CM CLARIFICATION #004

PROJECT: CNE Tahlequah Casino

ADDENDUM # 001

Tahlequah Casino Addendum #01 summary

S1.5
SAFER ROOM FOUNDATION PLANS

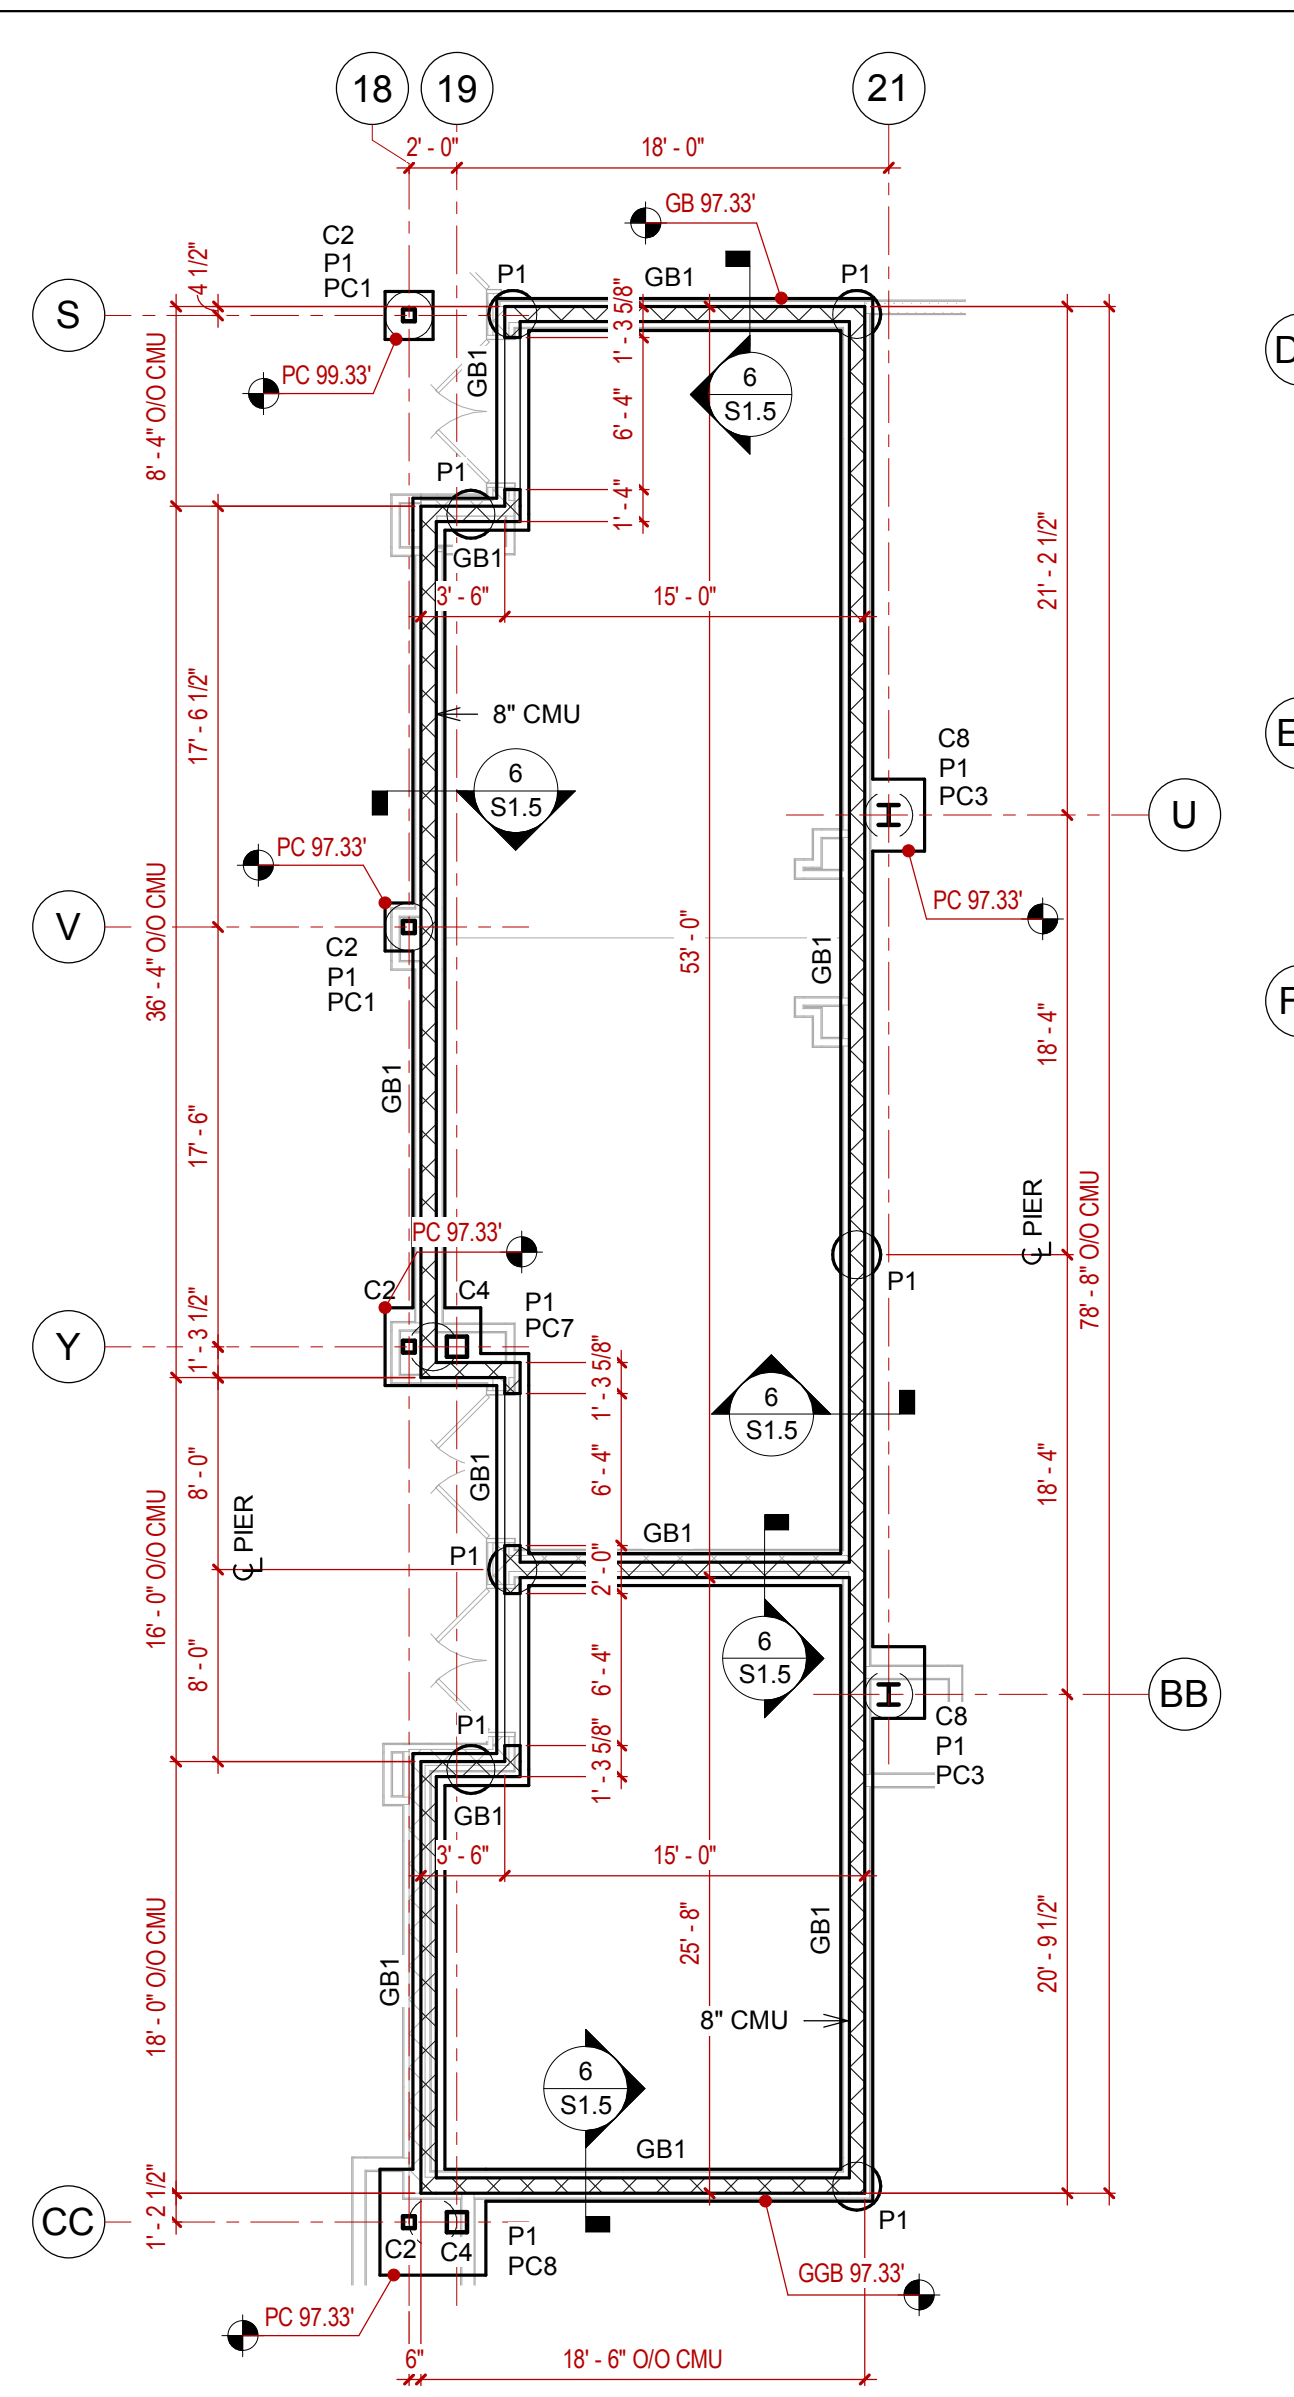
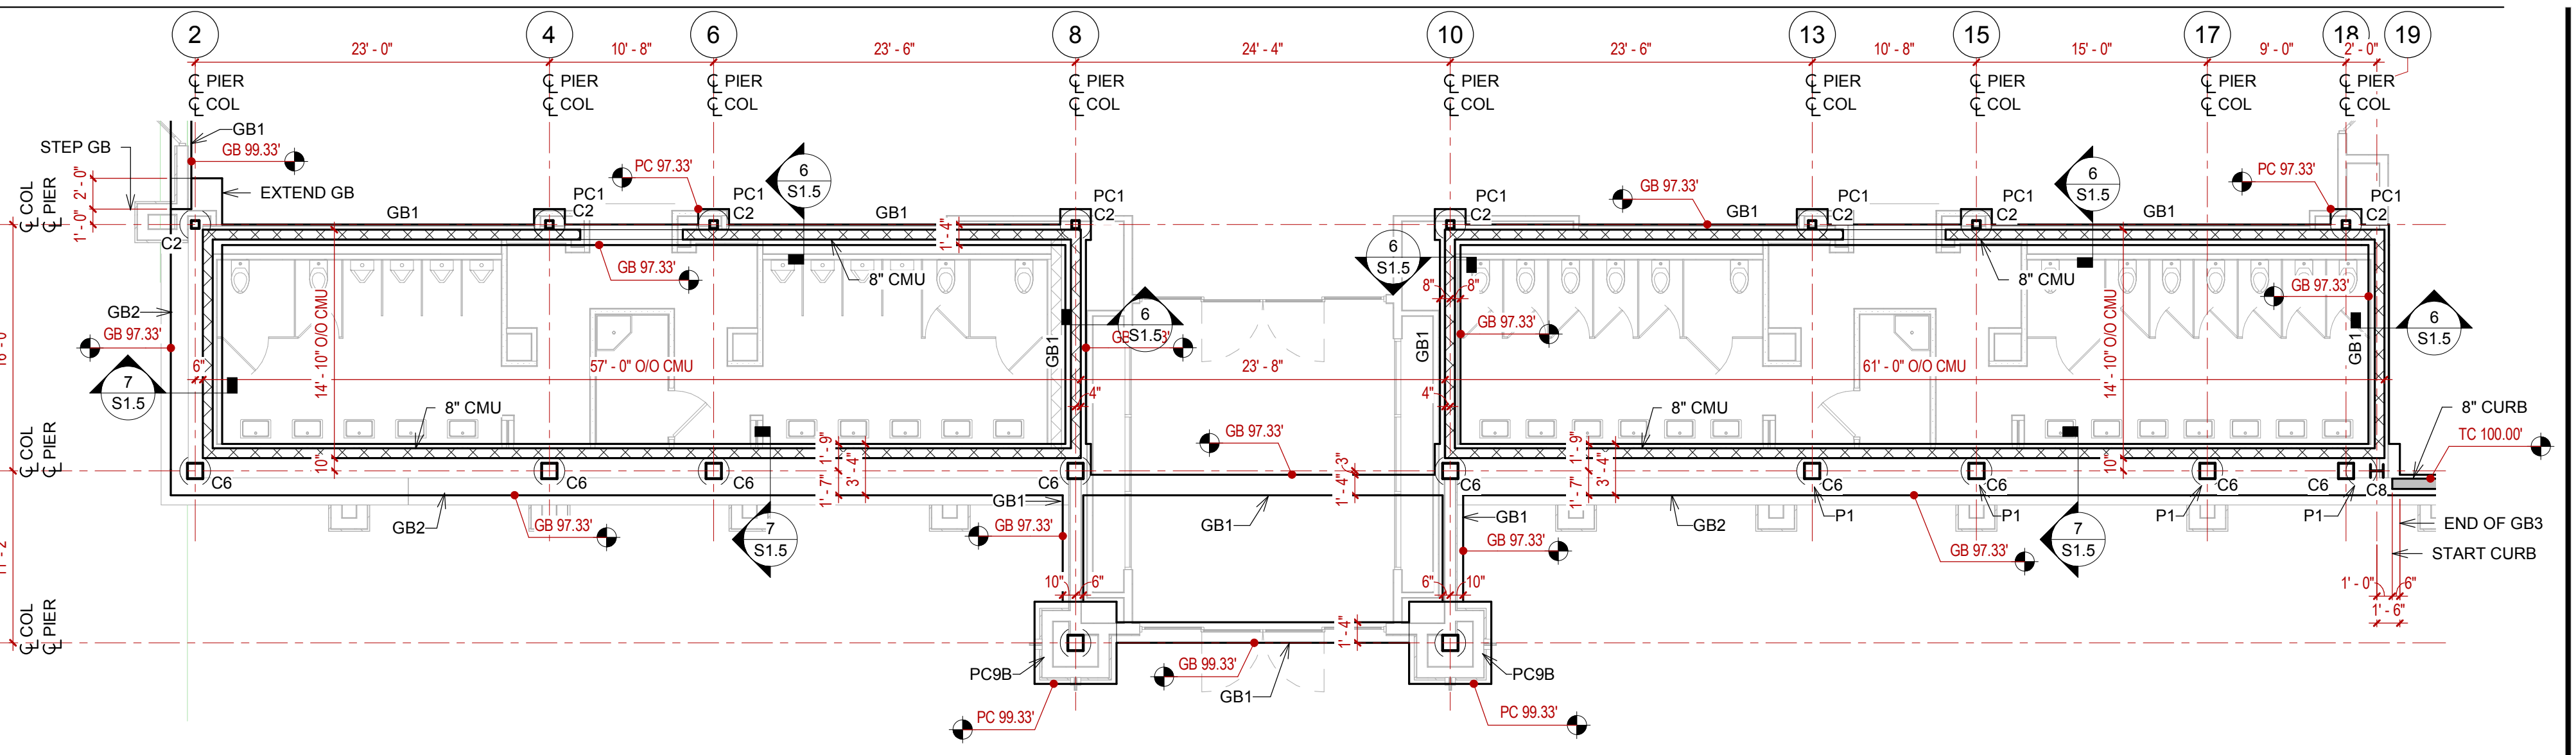
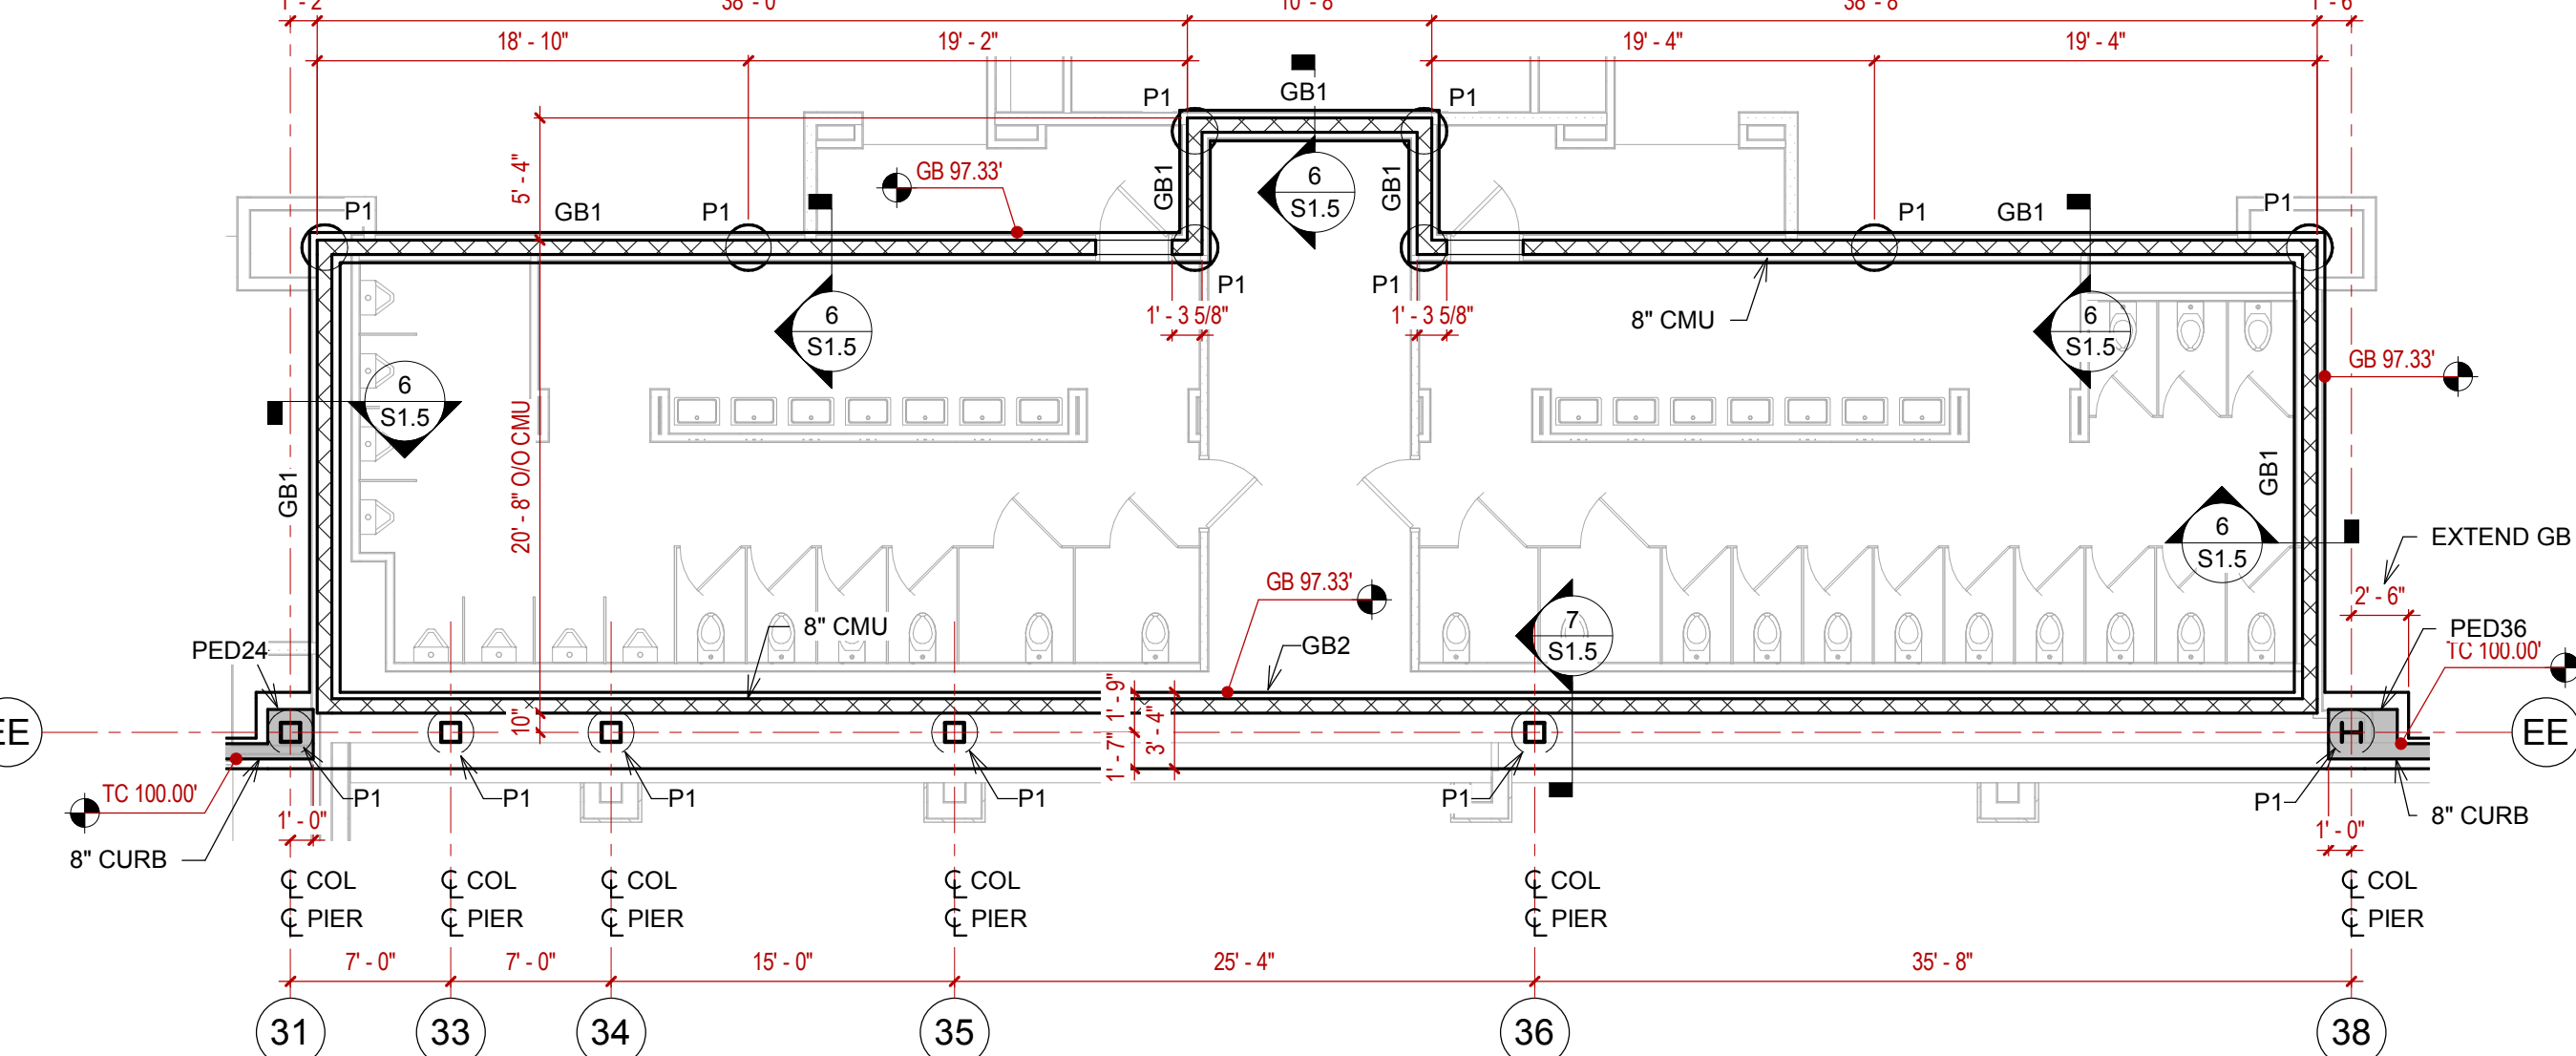
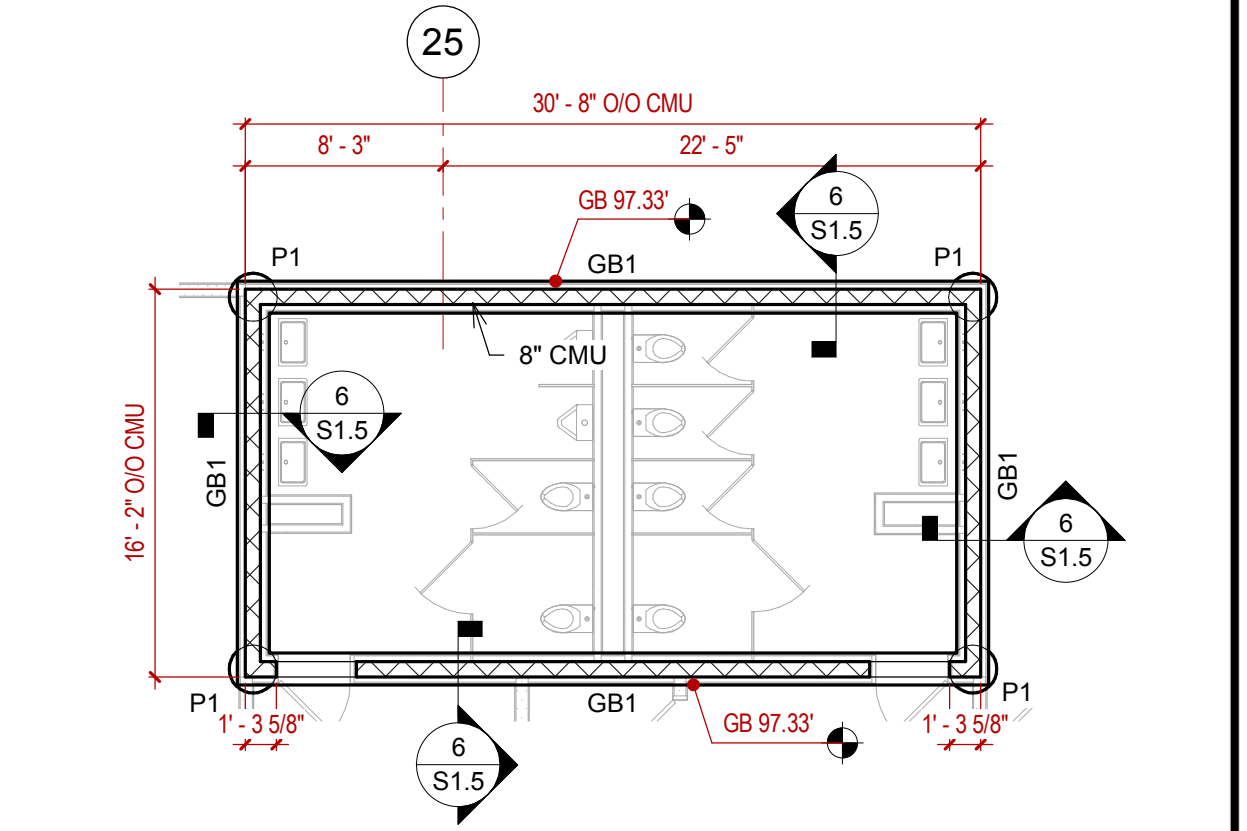
S1.5	Added sheet S1.5
S1.6	Added sheet S1.6
S1.7	Added sheet S1.7
S2.1	<ul style="list-style-type: none"> • Added enlarged stage pit plan and sections. • Added pit for dock levelers.
S3.1	<ul style="list-style-type: none"> • Revised roof deck to galvanize. • Revised column sizes.
S3.2	<ul style="list-style-type: none"> • Moved brace elevation from Y/BB-19 to U/BB-21 • Moved frame line 'DD' 1" east • Revised roof deck to galvanize. • Removed column @ U-19 & U-27.
